SUBJECT: Haymarket Baptist Church Final Site Plan

SUBJECT: HAYMARKET BAPTIST CHURCH – BUILDING ADDITION AND PARKING EXPANSION FINAL SITE PLAN, 14820 WASHINGTON STREET

Re: Haymarket Baptist Church
Alternative Screens and Modifications Request

DETAILS

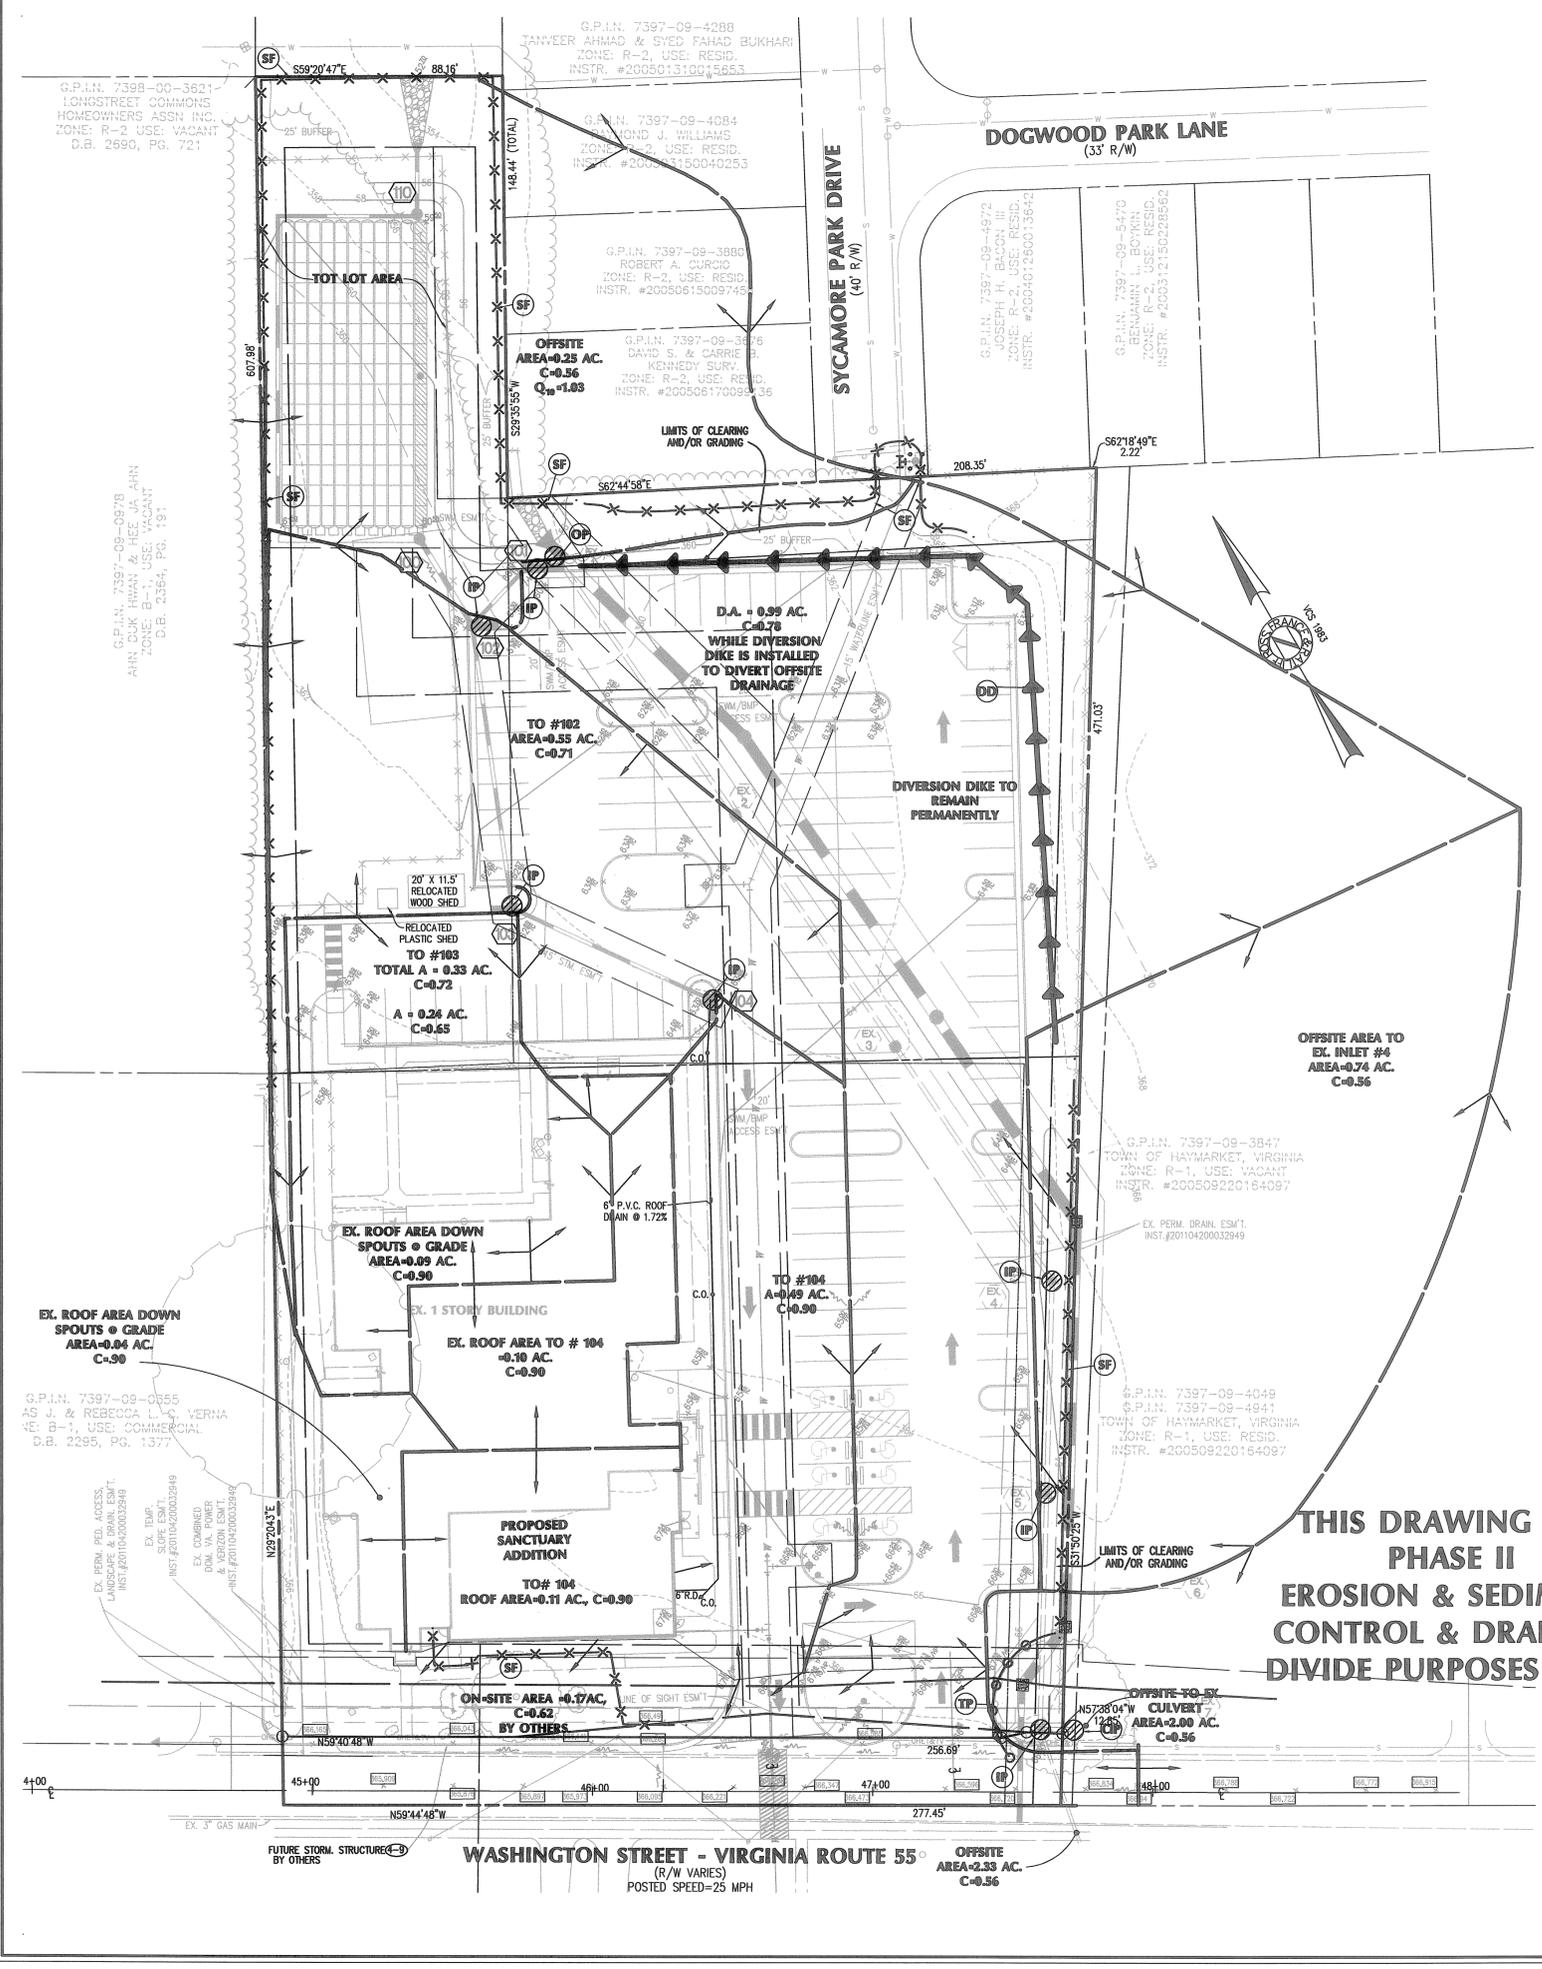
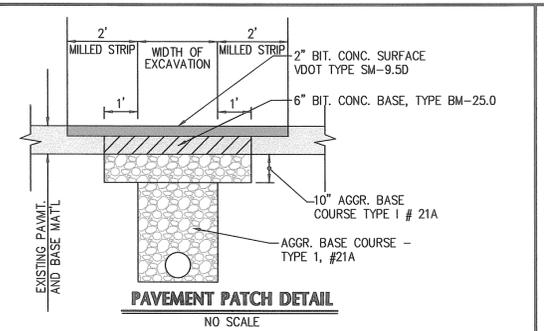
6. Sheet 3, Site Plan, Sheet 3a, Details, Dumpster Pad, note the dumpster pad with screen is to be provided per the Town of Haymarket Architectural Review Board Guidelines. The guidelines are posted online at www.townofhaymarket.org.

Response: Note has been added to sheet 3.

LANDSCAPE PLAN

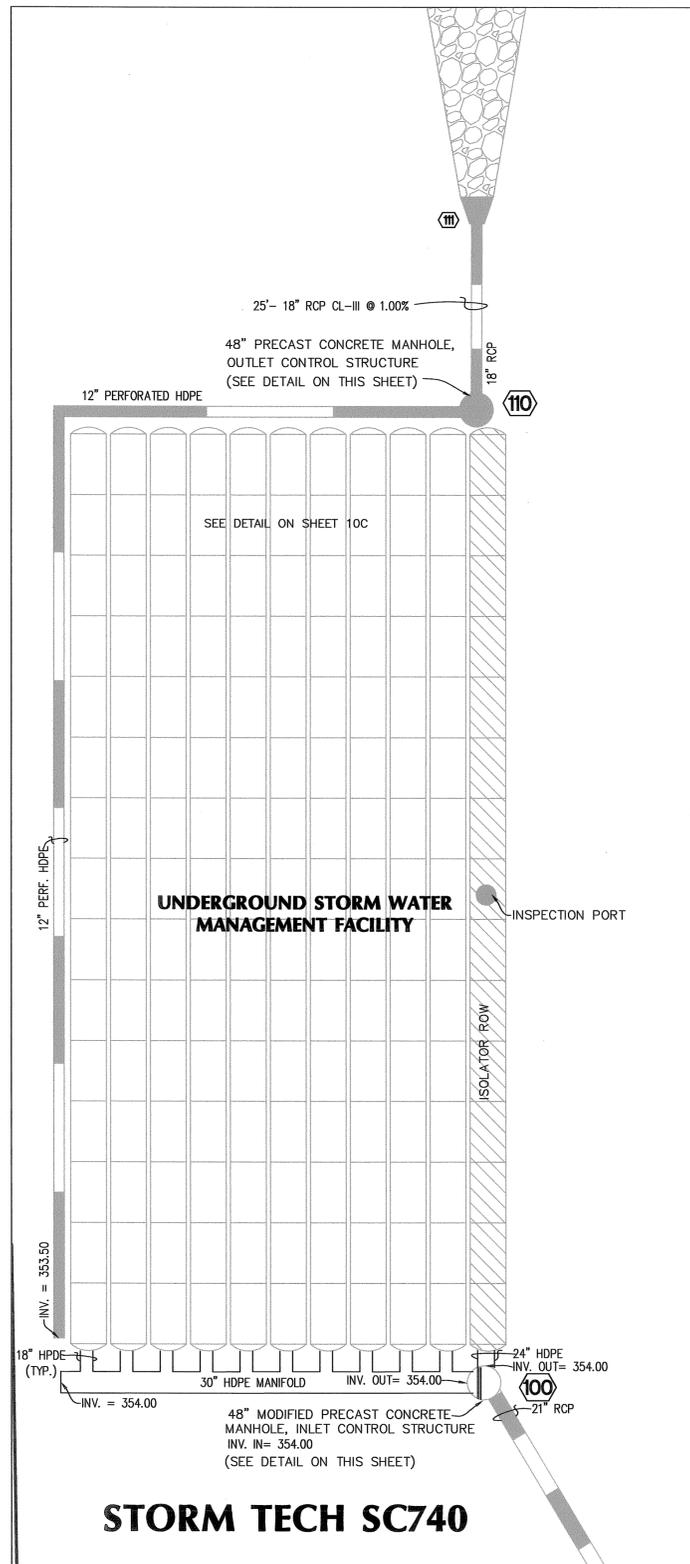
7. Sheet 6, Landscape Plan, "Screening and Buffer Yard Matrix", footnote 2 (**), replace "provided" with "proposed".
Response: Provided has been replaced by prosed on Landscape Plan.

8. Sheet 6, Landscape Plan, "Screening and Buffer Yard Matrix", footnote 3 (***), "...adjoining land use zone R-2" should reference B-1, note R-2.
Response: B-2 has been noted in place of R-2.

9. Sheet 6, Landscape Plan, "Screening and Buffer Yard Matrix", footnote 3 (***), strike the language followin "...no improvement in this area" and insert "... and an existing a 6 foot board on board fence has been provide as an alternative screening method. No additional method is applied." **Response: Language has bee changed as requested.**

10. Sheet 6, Landscape Plan, "Screening and Buffer Yard Matrix(es)", indicate the PIN#s to which the screen an buffer yard is applied.
Response: PIN #s have been added.

11. Sheet 6, Landscape Plan, "Screening and Buffer Yard Matrix", matrix for Footnote 2 (**), replace footnot language with "The standard buffer cannot be met pursuant to Section 58-702. Per Section 58-699(c), a alternate screen is provided by a 6 foot board on board fence adjacent to PIN# ____ and additional buffer area adjacent to the R-2 zoning districts along the northern property boundary. See Buffer Narrative this Sheet."

Response: Footnote language has been replaced.
13. Sheet 6, Landscape Plan, add an additional Schedule for perimeter parking lot landscaping adjacent to PIN# ____ (Section 58-703). Add a reference stating: "The standard perimeter parking lot landscaping cannot be met pursuant to Section 58-703(d). Per Section 58-703(f), an alternate screen is provided adjacent to PIN# ____ due to drainage infrastructure associated with the Washington Street Improvement Plan Phase IA and pedestrian interconnectivity with the adjacent Town owned properties."

7. Sheet 6, Landscape Plan, demonstrate conformance with Section 58-695, Contents of landscape plan.

8. Sheet 6, Landscape Plan, identify any dumpster locations. Screens are to be at least 8’ in height (Section 58-701(e)).

9. Sheet 6, Landscape Plan, demonstrate conformance with Section 58-699 and Section 58-700, Screening requirements. It would appear the requisite screens are not provided adjacent to the B-1, R-1, and R-2 districts.

11. Sheet 6, Landscape Plan, demonstrate conformance with Section 58-701 and Section 58-702, Buffer yard and Screening and buffer yard matrix. It would appear the requisite buffer yards are not provided adjacent to the B-1, R-1, and R-2 districts.

12. Sheet 6, Landscape Plan, demonstrate conformance with Section 58-703, Parking Lot Landscaping. It would appear the requisite landscape strip, trees, and screening of the parking lot from a public street is not provided.

13. Sheet 6, Landscape Plan, demonstrate conformance with Section 58-704 specific to all required buffers/screens.

14. Sheet 6, Landscape Plan, demonstrate compliance with Sections 58-716 (Sidewalks), Section 58-717 (Lighting), and Section 58-723 (Street trees). It would appear these improvements are not intended to be provided by the landowner.

Response: Footnote language has been replaced.
12. Sheet 6, Landscape Plan, "Screening and Buffer Yard Matrix", matrix for Footnote 3 (***), replace footnot language with "The standard buffer cannot be met pursuant to Section 58-702. Per Section 58-699(c), a alternate screen is provided by an existing 6 foot board on board fence adjacent to PIN# ____ and additiona buffer areas adjacent to the R-2 zoning districts along the northern property boundary. See Buffer Narrative thi Sheet."

Response: Schedule for perimeter parking lot landscaping has been added.
14. Sheet 6, Landscape Plan, add a note to the Sheet stating that the Washington Street Improvement Plan Phase 1A project will meet the Streetscape Requirements of Sections 58-713 through 58-526 as part of the building addition and parking lot expansion. Reference the Zoning Determination inserted on Sheet 3.

7. Sheet 6, Landscape Plan, demonstrate conformance with section 58-695, Contents of landscape plan. **Response: Landscape Plan is now in conformance with section 58-695.**

8. Sheet 6, Landscape Plan, identify any dumpster locations. Screens are to be at least 8' in height (Section 58-701(e)). **Response: Comment noted and presently there are no dumpster locations planned.**

9. Sheet 6, Landscape Plan, demonstrate conformance with Section 58-699 and Section 58-700, Screening requirements. It would appear the requisite screens are not provided adjacent to the B-1, R-1, and R-2 districts. **Response: Screening has been provided through landscaping and fencing.**

11. Sheet 6, Landscape Plan, demonstrate conformance with Section 58-701 and Section 58-702, Buffer yard and Screening and buffer yard matrix. It would appear the requisite buffer yards are not provided adjacent to the B-1, R-1, and R-2 districts. **Response: Adequate buffering has been provided between the different uses.**

13. Sheet 6, Landscape Plan, demonstrate conformance with Section 58-704 specific to all required buffers/screens. **Response: The landscape plan has been revised to demonstrate conformance.**
14. Sheet 6, Landscape Plan, demonstrate compliance with Sections 58-716 (Sidewalks), Section 58-717 (Lighting), and Section 58-723 (Street trees). It would appear these improvements are not intended to be provided by the landowner. **Response: Sidewalks, lighting and street trees shall be provided with the street enhancement project.**

SHEET 6 OF 10
FILE NO.: SP #1592

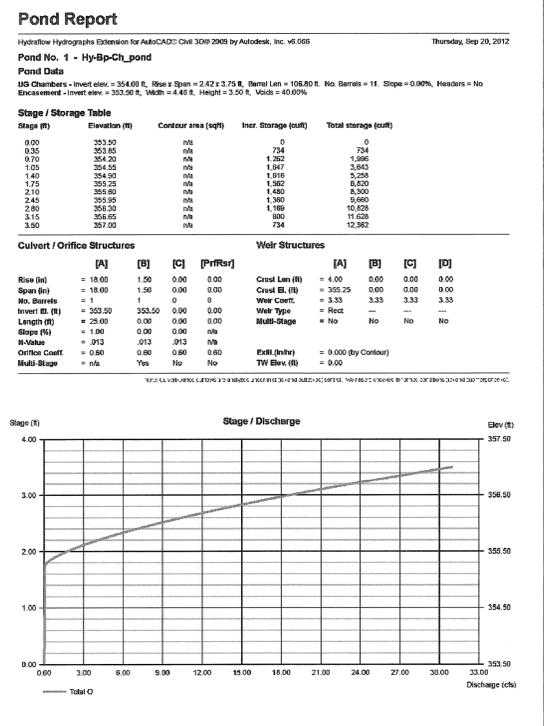
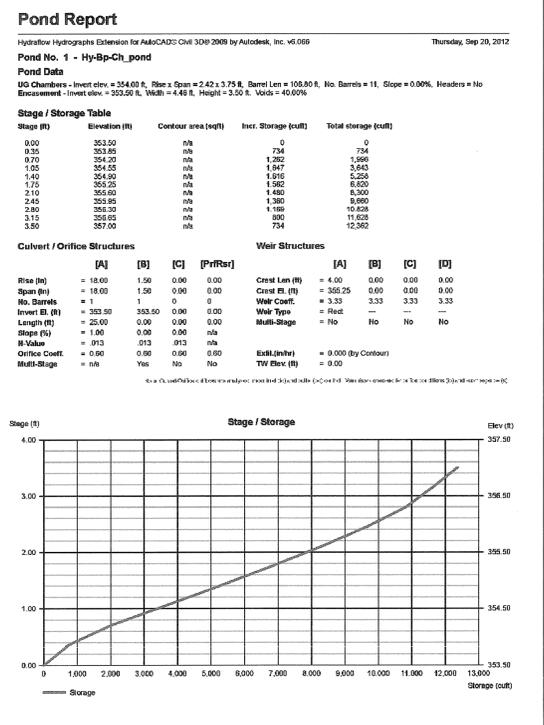
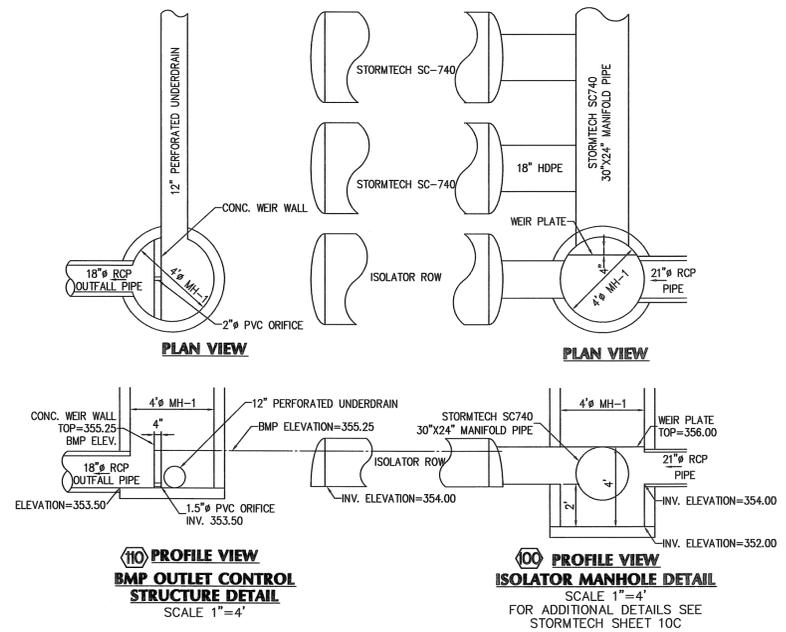
1. Modification to Section 58-701 and -702, Buffer Yard. Zoning Ordinance § 58-702 requires a 25' opaque screen between B-1 and R-1 zoned properties. As depicted on the Landscape Plan, the Church is proposing a 6' tall wooden fence along the entirety of its western property line to satisfy the buffer yard requirement, which will provide a completely opaque screen in this location. Currently, there is a 6' tall fence along the boundary with GPIN 7397-09-0555, and a new 6' tall fence is proposed along the boundary with GPIN 7397-09-1178. The Church's request is justifiable because i) the use of the property is compatible with the B-1 zoning of the commercial properties, i.e. it is dissimilar from a traditional residential use, ii) there is insufficient room to provide a 25' buffer considering the location of the existing Church structure and the location of the proposed stormwater management facility and tot lot, and iii) additional buffer area is

being installed adjacent to the R-2 zoning district along the northern property boundary. The additional buffer is shown on attached sheet 6.
